New bushing for the S3 castor wheel

We now introduce a new design of the bushing for the S3 castor wheel. This is to simplify the logistics and the mounting of the castor wheel onto the castor fork.

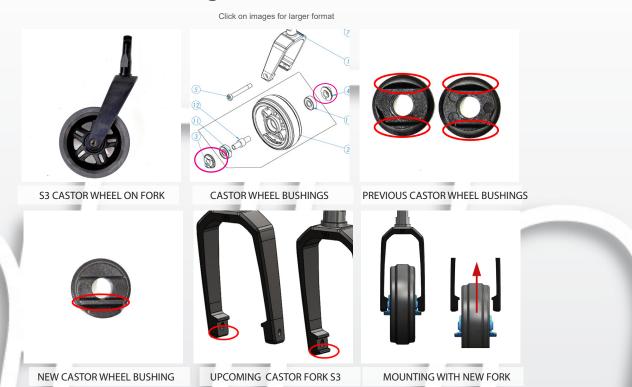
The previous bushings for the S3 castor wheels came in two versions, one for the left and one for the right side. Now we replace these two with one version that fits both sides. With only one edge on the new bushing it becomes easier to mount.

We will also later on, introduce un updated castor fork. When the lower edge disappear, see image, it becomes much easier to mount the castor wheel onto the castor fork.

Both versions of the bushings fits both versions of the castor fork.
